Bid 17-22 2017 Construction of Wheelchair Ramps and Sidewalks - Various Locations

Addendum #1 Contractor Question Responses

PIAUES 41

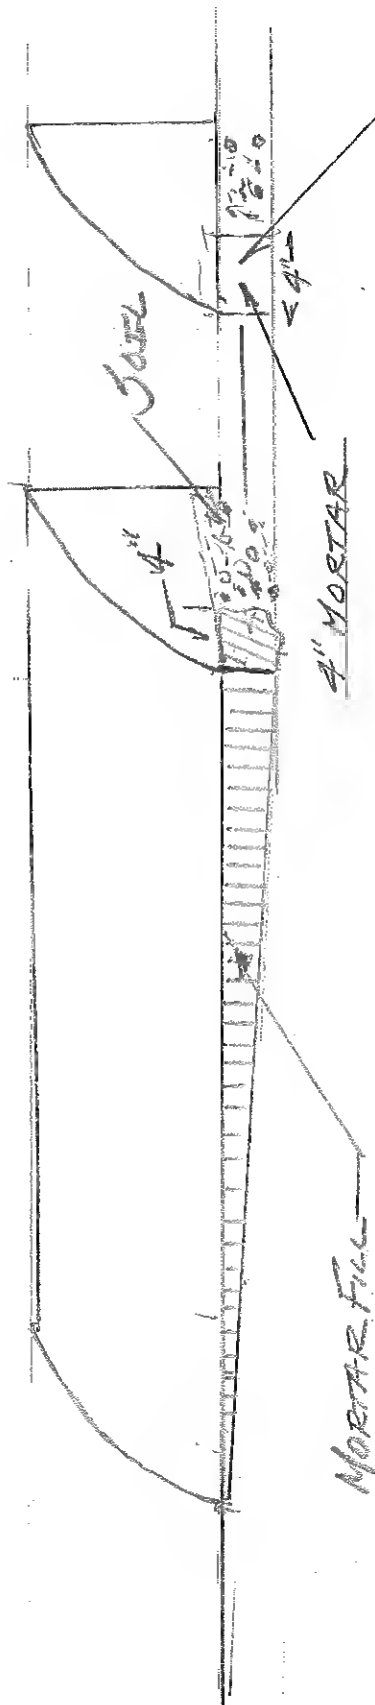
1. **Q: Item #23 on pg.9, COBBLE STONE FURNISHED BY CONTRACT, not clear of definition and would like clarity and typical detail.**

A: Cobblestones as specified 4"- 6"W X 6"- 8"D X 10"-12"L to be installed on edge and will be paid by linear foot as measured along back edge of sidewalk. See Figure #1.

METALLES LEUANT BY LINSHARK FOOT

COBBLE STONE INSTALLED
